Revision	Date	Description	Prepared By	Checked By
N1	07.08.20	Medius House Mechanical Ventilation	NL	DP

The purpose of this file note is to demonstrate and justify the fresh air intake locations related to the Medius House redevelopment and change of use to residential units. This is in response to LBC’s comments relating to Planning Condition 34:-

MVHR – Condition 34:

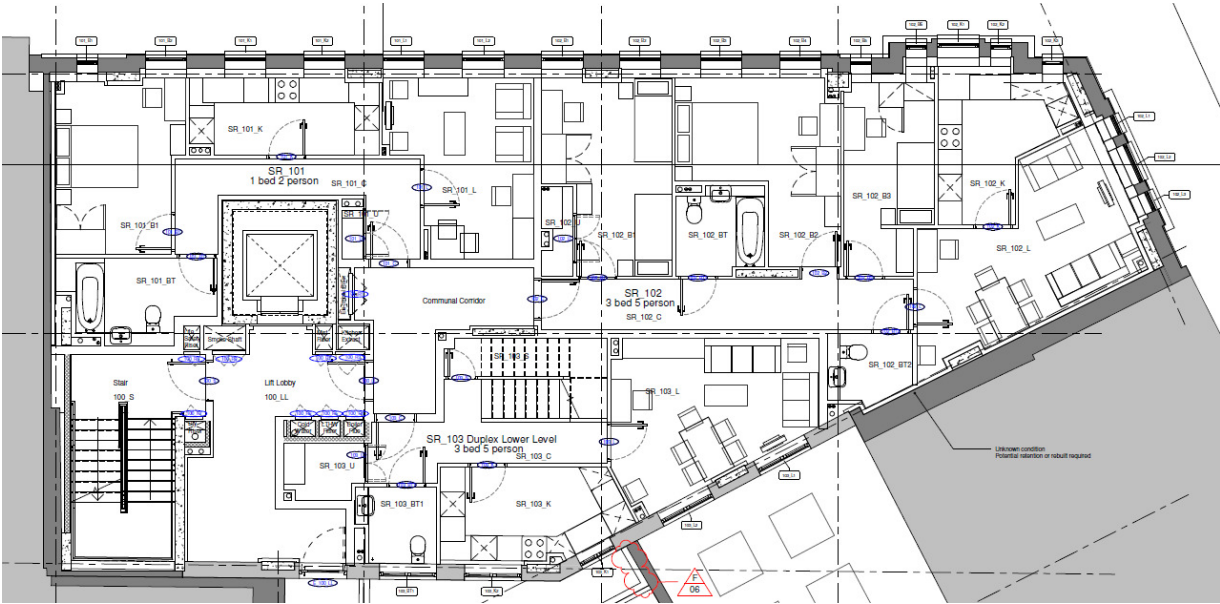
The response states that “The Medius House Apartments have always been based on individual systems for each apartment, not a centralised system.”

However, the AQA section 6.2 from the approved application clearly states that the air inlet should be positions at the rear at the highest point possible and this was set out in the condition.

In order to completely satisfy the AQA’s suggestion that fresh air inlets should be to the rear, and as high as possible, it would require the fresh air intake ducts to pass from each Apartment to the front of the building, across the communal corridor, and then through rear apartments to either connect to the rear façade, or to rise to a higher part of the building through before connecting to the rear façade, or terminate at roof level.

This presents a number of issues, namely access and maintenance (for cleaning), where ducts pass through different Apartments, increased ductwork resistance, and potential loss of critical Apartment floor area (~in order to accommodate vertical risers). MVHR units have a relatively low limit of available fan pressure, and hence the duct routes need to be kept to a minimum to achieve the flow rates required to comply with Part F of the Building Regulations.

Medius House's floor to ceiling heights are very low, and hence detailed coordination was undertaken to ensure duct runs were kept to a minimum and generally positioned through Apartment hallways to allow living area ceilings to be raised to their maximum. To route ductwork across to the rear façade would require various ducts to cross over within living areas, reducing ceiling heights by a further 200mm.

Introducing a fresh air shaft to roof level was explored and deemed not feasible, as the shaft size could not fit within the core layout, whilst maintaining the required size of lobbies for access. The shaft would have protruded into the amenity areas at roof level. A set of spill fans to push air down the shaft would be required at the top of the shaft, meaning an acoustic louvred screen would be required to visually isolate the fans from areas of the amenity space, along with providing a level of acoustic attenuation.

In conclusion, the AQA's suggestion to bring fresh air in from the rear of the building from a point as high as possible "where feasible" had been explored at design stage however it was deemed not feasible for the reasons set out above. The use of NOX filters has been implemented as a mitigation as recommended.
